**ADDENDUM
TO
REPORT NO. 1755-010606-D**

REVISION: C
DATE OF ISSUE: JUNE 14, 2007

**UPDATED NOISE MODELING RESULTS
BASED ON NEW DATA FROM CLIPPER WINDPOWER**

COHOCTON WIND FARM PROJECT

Figure 2.2.1 Preliminary and Current 1/3 Octave Band Sound Power Level Spectrum for the Clipper C96 Wind Turbine (from Prototype Field Measurements)

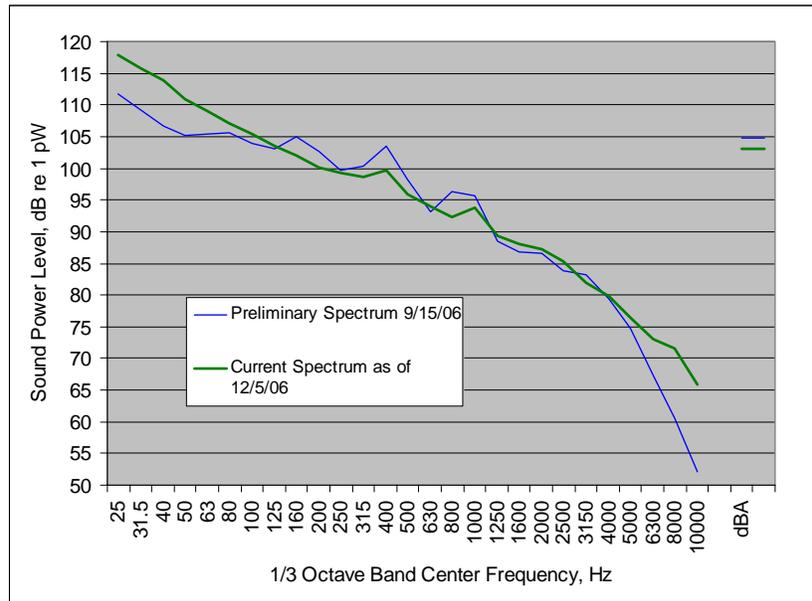
The more detailed 1/3 octave band sound power level spectrum of the prototype before and after modifications is shown below. The principal goal of the mitigation was to minimize the slight prominences at 160, 400 and 1000 Hz and smooth out the spectrum.

Finally, the Ordinance limits tonal noise to a set of specific 1/3 octave band exceedances applicable in different regions of the frequency spectrum (see Section 2.1.1). As illustrated in Figure 2.2.1, the acoustical modifications to the prototype turbine have significantly reduced the minor prominences that had previously existed in the sound power level spectrum. There is no longer any prominence at 160 Hz and the 400 and 1000 Hz “tones” have been substantially suppressed.

Description:
Graphic B
 Predicted Sound Contours (dBA)
 of Wind Turbines with
 Omnidirectional 8m/s Wind
 NYSDEC Second Level Evaluation

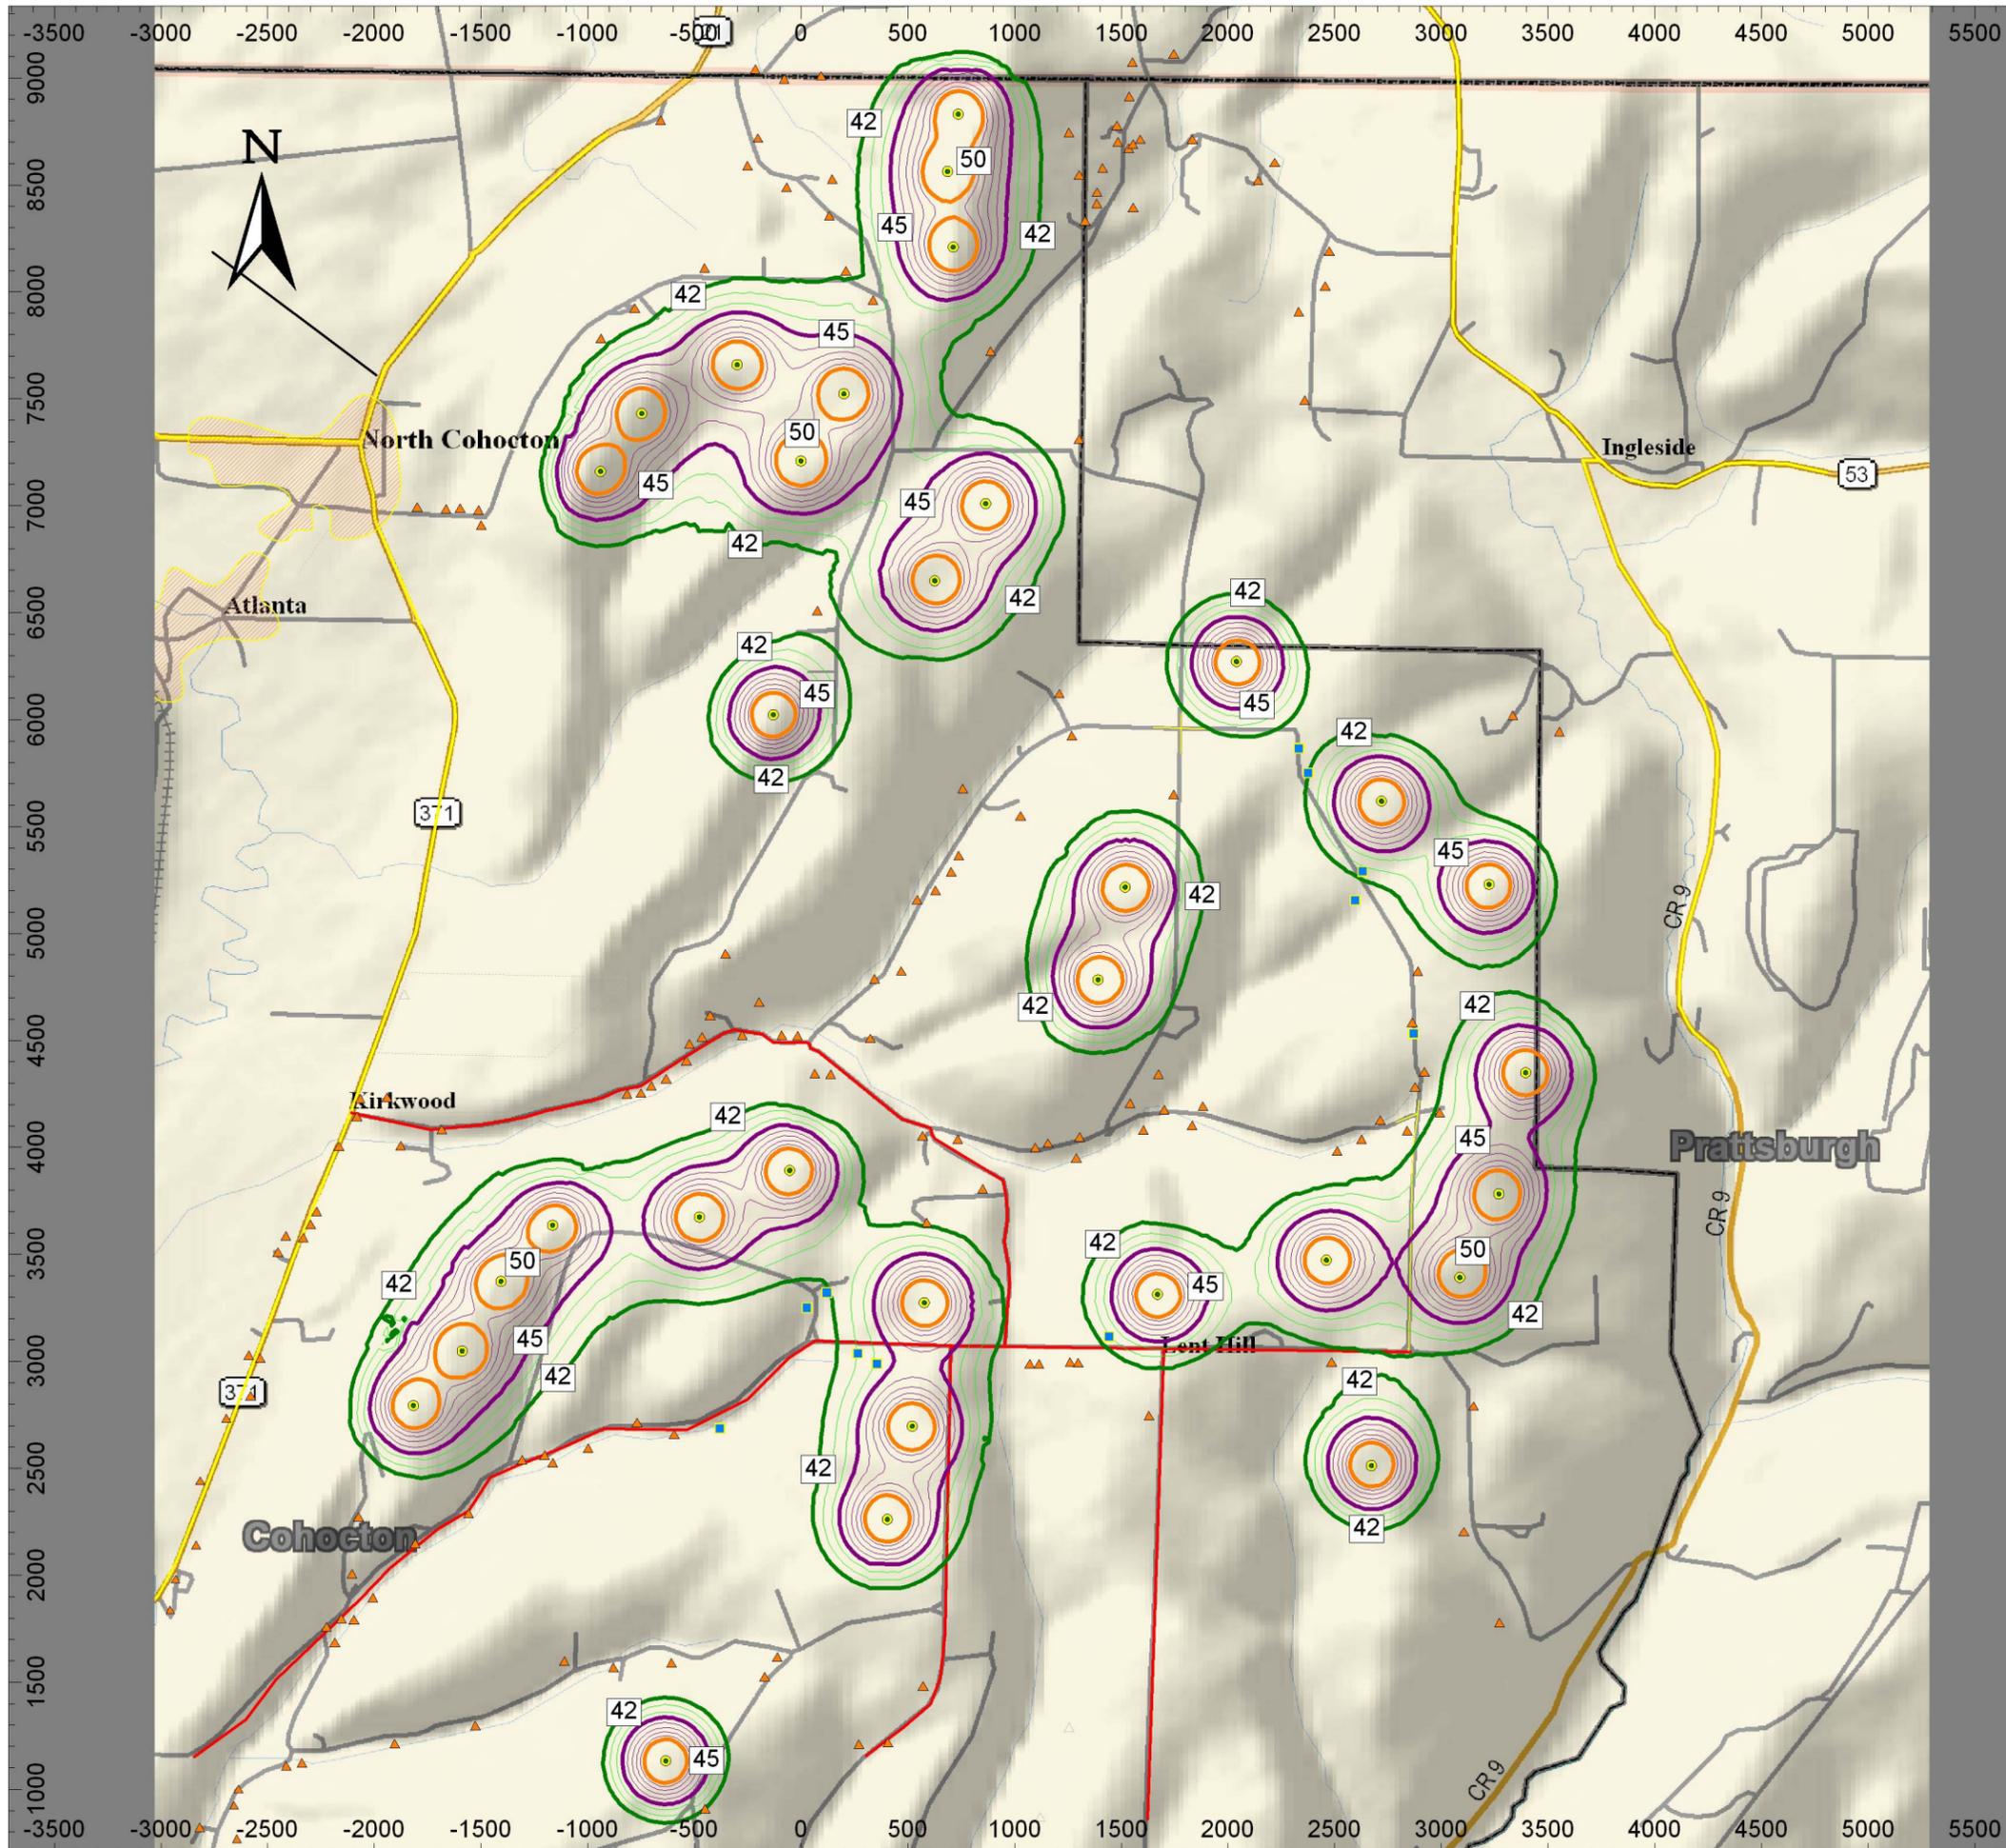
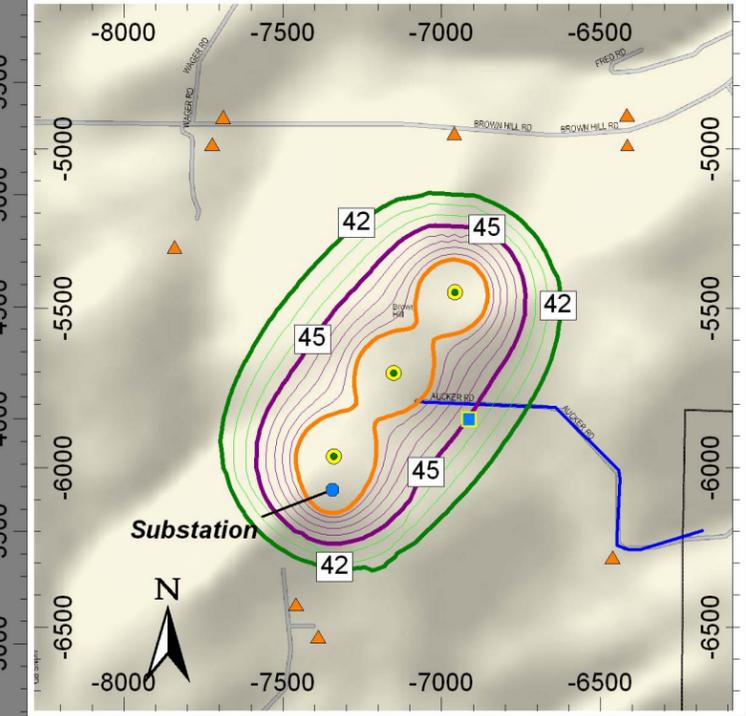
The overall results of the Second Level model with the new turbine sound power level are shown in **Graphic B**. This plot represents a conservative view of what can be expected with all turbines operating at their maximum noise point assuming an omni-directional 8 m/s wind. Non-participating residences are represented by yellow triangles and blue boxes indicate the homes of project participants.

The area inside of the 42 dBA sound contour (shown in green) represents the region where noise from the project may be audible above the residual (L90) background level; i.e. where the cumulative sound level is expected to be 6 dBA or more above the pre-existing level.

Relative to the plots in the original assessment report based on preliminary measurements of the unmitigated prototype, this plot is notable in that far fewer residences lie on or inside the region bounded by the 42 dBA contour. This means that the vast majority of residents in the project area, where sound levels are predicted to be less than 42 dBA, will be largely or completely unaffected by project noise. Only three non-participating residences may potentially experience sound levels in the 42 to 43 dBA range under worst-case circumstances. The remaining 7 homes on or inside the 42 contour belong to project participants where an adverse reaction to project is unlikely. The predicted sound level at most of these participating homes is also in the vicinity of 42 to 43 dBA with one, in the Brown Hill section, at 44 dBA.

The second condition of the Ordinance limits project noise to 45 dBA outside any non-participating residences. As illustrated in Graphic B, the maximum predicted sound level at any non-participating residence is just under 43 dBA so compliance is anticipated at all residences under all wind conditions.

Graphic C
Predicted Sound Contours (dBA)
of Wind Turbines with
Omnidirectional 8 m/s Wind
NYSDEC Second Level
Evaluation Calculation Criteria

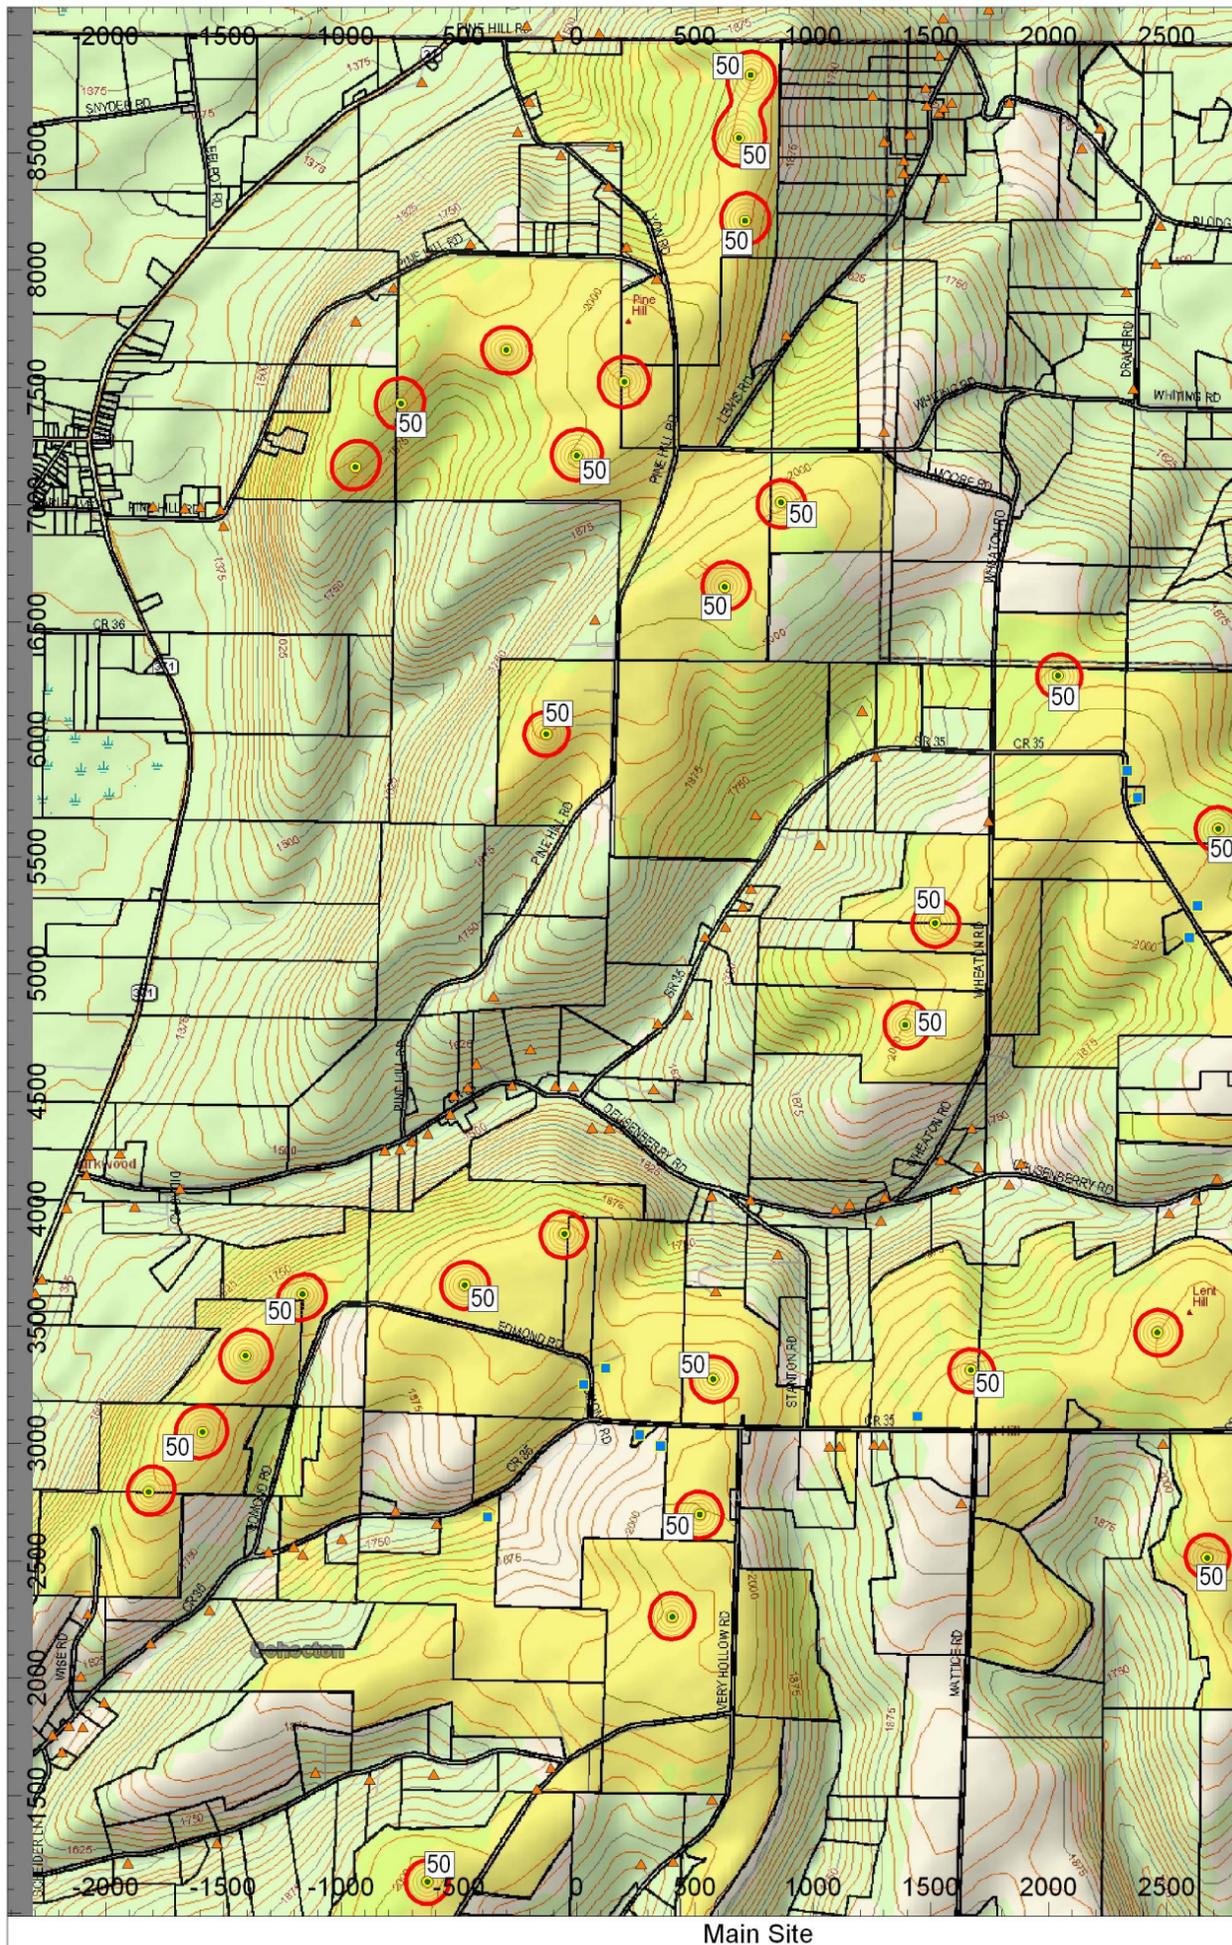
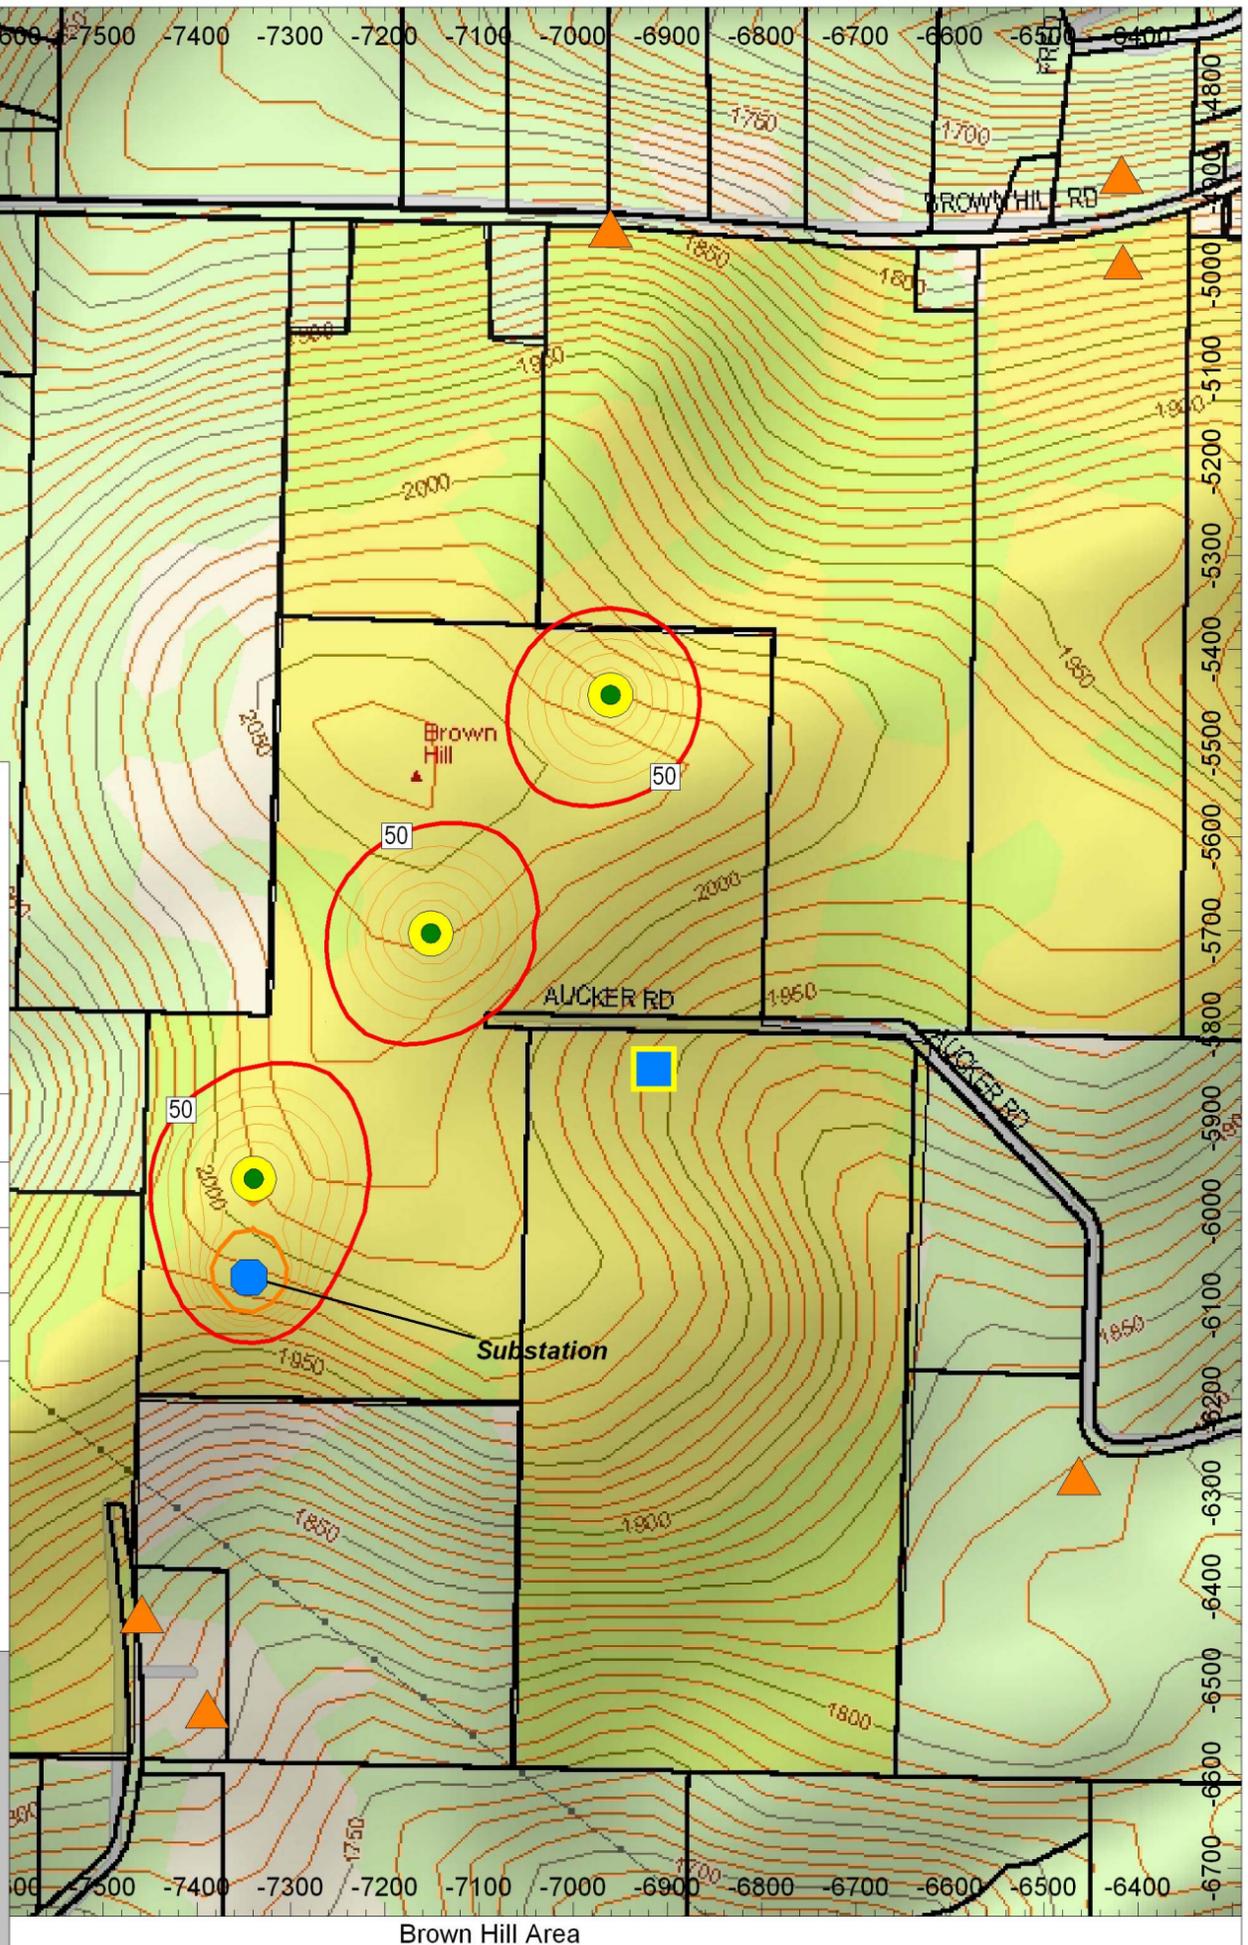
The Town of Cohocton Noise Ordinance limits noise exclusively from the project to 50 dBA at the property line of any parcels of land belonging to non-participants in the project. **Graphic C** shows the 50 dBA sound level contour using the new turbine sound power level, calculated under the conservative conditions described above, relative to the land parcels owned by project participants (shaded yellow).

This graphic illustrates that project sound levels of 50 dBA or more will be confined to participating properties. It is also important to note that these sound levels would only occur intermittently during windy conditions and there would be no noise whatsoever from the project at these property boundaries during calm or low wind conditions.
